| By mail, send to: | Mail Stop ISSUE Commissioner for P.O. Box 1450 Alexandria, Virgin | Patents nia 22313-1450 | | | • | s, send to: | (571)-273-2885 |
|---|--|---|---|---|---|---|--|
| TITLE OF INVENTION | N: DISPLAY BOARD | | | | | | |

Notice of Allowability For A Design Application

Continuation of Acceptable drawings filed on: 2/11/2021

AMENDMENT AND RESPONSE TO NON-FINAL OFFICE ACTION

FIG. 10

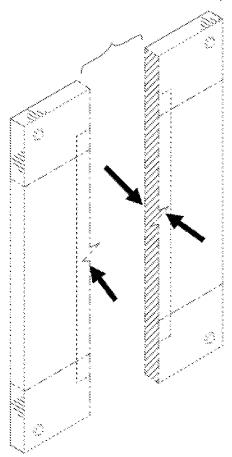
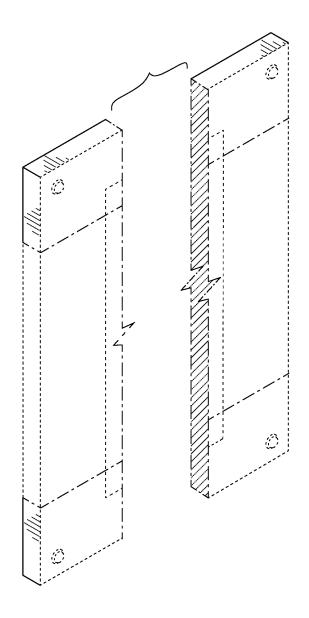
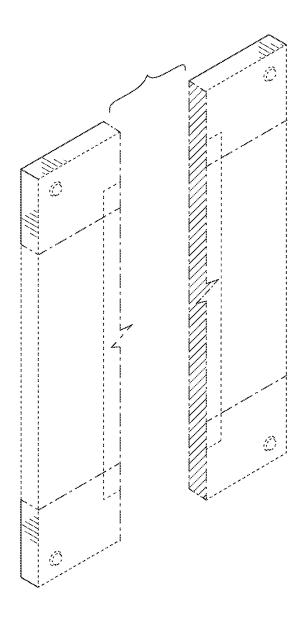
The attached sheet of drawings includes changes to Fig. 10. This sheet 8/10, which includes Fig. 10, replaces the original sheet including Fig. 10. In Fig. 10, previously omitted jagged break line has been added to the front plane of the article. Applicant submits no new matter has been added.

On pages 5-8, the Examiner alleges there is an inconsistency with the jagged break line in Fig. 10 compared to Figs. 9, 11 & 12. Without acquiescing to these rejections, Applicant submits herewith replacement drawings with revisions to Fig. 10 adding a jagged line break to

• There is an inconsistency with the jagged break line. In Figs. 9, 11 & 12, the jagged line break goes all the way through the design, from front to back, but in Fig. 10, the jagged line break is visible on the back plane of the design, but not on the front.

To overcome this portion of the rejection, it is suggested that applicant submit new drawings of the claimed design that show the design clearly and consistently.

FIG. 12

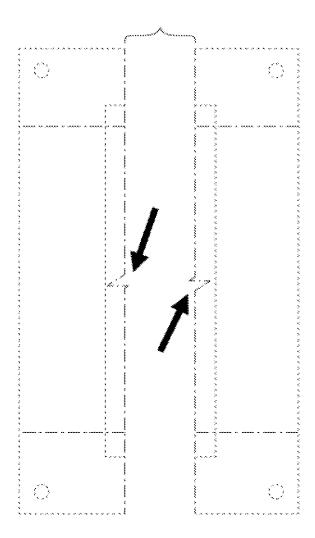
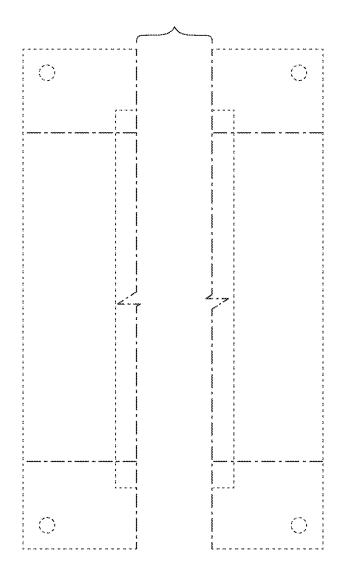
On pages 3-4, the Examiner alleges the claimed subject matter on the back of the article illustrated in Figs. 10 and 12 is unclear. According to the Examiner:

In Figs. 10 and 12, it is unclear what is claimed subject matter on the back of the article. Since boundary lines define the claim, everything outside of them can be understood to be claimed, but there are dot-dot broken lines that are outside of what is understood the boundary to be, making it impossible to understand. Additionally, there is no shading in some areas outside the boundary lines either, causing even more confusion. A question arises as to exactly what is being claimed, thereby rendering the claim indefinite and making it impossible for one skilled in the art at the time the invention was made to make or reproduce the design.

• In Figs. 10 and 12, it is unclear what is claimed subject matter on the back of the article. Since boundary lines define the claim, everything outside of them can be understood to be claimed, but there are dot-dot broken lines that are outside of what is understood the boundary to be, making it impossible to understand. Additionally, there is no shading in some areas outside the boundary lines either, causing even more confusion. A question arises as to exactly what is being claimed, thereby rendering the claim indefinite and making it impossible for one skilled in the art at the time the invention was made to make or reproduce the design.

Applicant respectfully disagrees that the claimed subject matter on the back of the article illustrated in Figs. 10 and 12 is unclear. Similar to Embodiment 1 (Figs. 1-8), Embodiment 2 (Figs. 9-16) disclaims the entire rear surface. Applicant submits that the dotted lines and lack of shading in Figs. 10 and 12 is consistent with Fig. 4 which has not been objected to. However, in Embodiment 2, only the top and bottom recesses are claimed, and only the outer portions. Thus, the board could be wider or narrower than the cited art, and also taller or shorter. However, what has been claimed or disclaimed has not otherwise changed compared to Fig. 4. For example, in Fig. 10, on the left portion of the design, nothing to the right of the vertical boundary line is claimed. The design to the left of the boundary line is claimed. However, the entire back surface is disclaimed, while the top and left surfaces are claimed (except between the two horizontal boundary lines). Withdrawal of this rejection is respectfully requested.

U.S. Patent Dec. 15, 1987 Morin D293,185

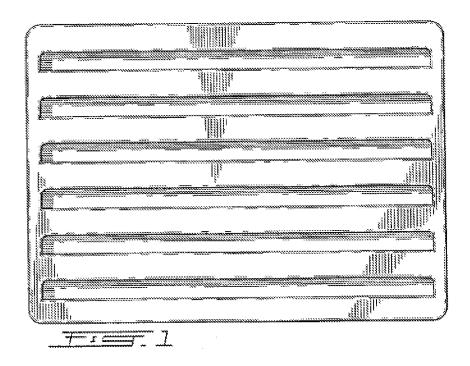
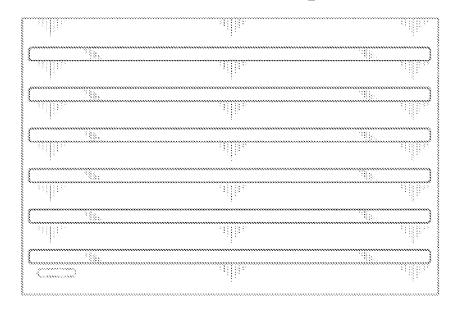
Applicant respectfully submits that the Examiner has failed to identify all of the differences between the claimed design and the closest prior art reference Morin. Specifically, the Examiner has failed to identify the differences between the depth of the recesses of the claimed design and Morin. Applicant submits that the recesses of the claimed design are significantly more shallow compared to the depth of the recesses in Morin. To illustrate this contrast, shown below in cross-section is Fig. 6 of Morin compared to the claimed design, and Morin's recesses have a significantly greater depth than the claimed the display board. Applicant submits that this difference is significant and not inconsequential.

The following are differences between the claimed design and the prior art:

• The claimed design has sharp corners on the outer rectangle and all rounded corners on the inner recesses

U.S. Patent Dec. 12, 1995 Krawitz Des. 365,121

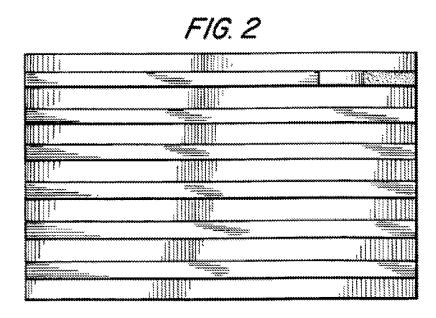
Applicant submits that Krawitz and Cobb fail to make up for this deficiency. Krawitz is cited for allegedly teaching sharp corners of the outer rectangle of a display board and does not purport to disclose recesses. Regarding Cobb, Applicant submits that Fig. 4A of Cobb, included on page 12 of the Office Action, is the rear view of the display board and not the front view where Morin and Applicant's recesses are disposed. Applicant submits that one would not be motivated to modify the appearance of the front of Morin's display board in view of the appearance of the back of a Cobb's display board. Moreover, Applicant submits Cobb does not teach or suggest recesses like either Morin and Applicant's recesses, because Cobb's interior rectangles are windows 44, or cut-outs, which penetrate through the entire depth of the display board, and are therefore not recesses.

The secondary reference, of U.S. Design Patent D365,121-S, published 12/12/1995, Krawitz (892 K, 1st page), below shows sharp corners on the outer rectangle of a display board.

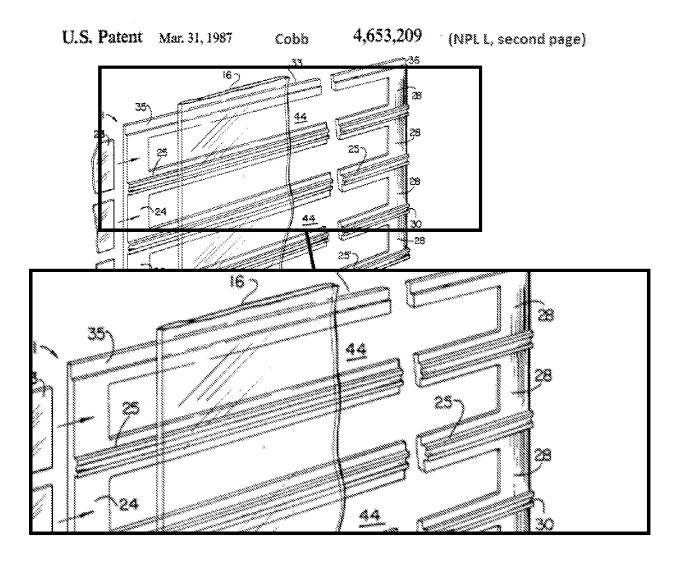
Applicant submits Cobb is not analogous art to the claimed design. Cobb's board is used to display the names and office locations for occupants in an office building. It is not clear that there are rounded corners. Moreover, the "inner recesses" are cut-out windows 44 in a vertical panel 12 and not recessed into the panel like the claimed design and Morin's. Applicant submits there would be no record-supported reason to modify the recesses of Morin, which have a significantly greater depth than the claimed display board depth, in view of Cobb's board which has cut-out windows 44 going all the way through the display board. Accordingly, Applicant requests withdrawal of these rejections.

The secondary reference, of U.S. Patent 4,653,209, published 3/31/1987, Cobb (892 L, 2nd page), below shows rounded corners on the inner recesses of a display board.
